Access Compliance Report

Public Rights-of-Way

(Curb Ramps)

Intersection ID: 52927	Main Street: EMORY_OAK_DR	Cross Street: GRAY_OAK_LN	Location: S
ADA ID: 31802F76F5A0	Ramp Type: Perp	Initial Pass/Fail: Fail	Overall Compliance: No
Severity Score: 8.75			
Codes/Mitigation Info/Possible Solution		Field Measurements/Component Compliance

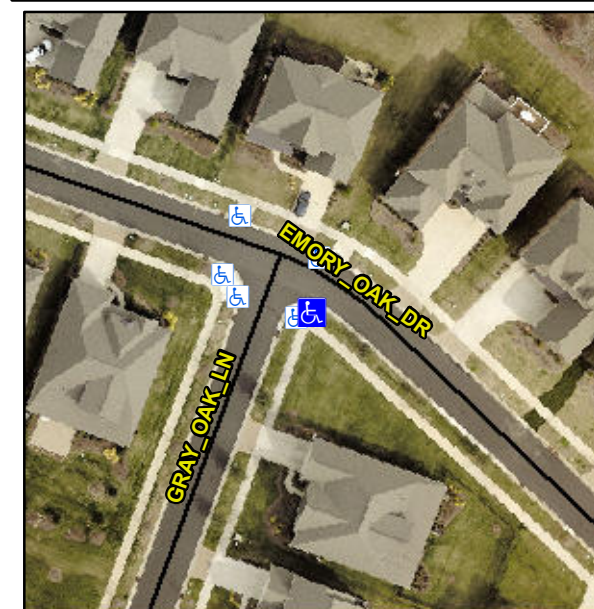
Not Found, R304.5.1

Compliance	Description	Data	Compliance	Description	Data
N/A	Ramp Length (in)	73.0	Yes	Ramp Slope (%)	5.3
No	Ramp Width (in)	37.0	Yes	Ramp XSlope (%)	0.8
N/A	Flare Type LT	N/A	N/A	Flare Type RT	N/A
N/A	Flare Slope LT (%)	N/A	N/A	Flare Slope RT (%)	N/A
N/A	Flare Traversable LT?	N/A	N/A	Flare Traversable RT?	N/A
N/A	Landing Length (in)	N/A	N/A	DWS Provided?	N/A
N/A	Landing Width (in)	N/A	N/A	DWS Contrast?	N/A
N/A	Landing Slope (%)	N/A	N/A	DWS Length (in)	N/A
N/A	Landing X Slope (%)	N/A	N/A	DWS Full Width?	N/A
N/A	Landing Curb? (Y/N)	N/A	N/A	DWS Offset (in)	N/A
N/A	Shared Landing?	N/A			
N/A	Gutter Ponding?	N/A	N/A	Gutter Slope (%)	N/A
N/A	Gutter Lip Ht (in)	N/A	N/A	Gutter X Slope (%)	N/A
N/A	Painted X Walk1?	No	N/A	Painted X Walk2?	N/A
	X Walk 1 Direction	To N		X Walk 2 Direction	N/A
N/A	X Walk 1 Width (in)	N/A	N/A	X Walk 2 Width (in)	N/A
	X Walk 1 Slope (%)	4.5		X Walk 2 Slope (%)	N/A
	X Walk 1 X Slope (%)	3.1		X Walk 2 X Slope (%)	N/A

Remove & Replace Entire Ramp.
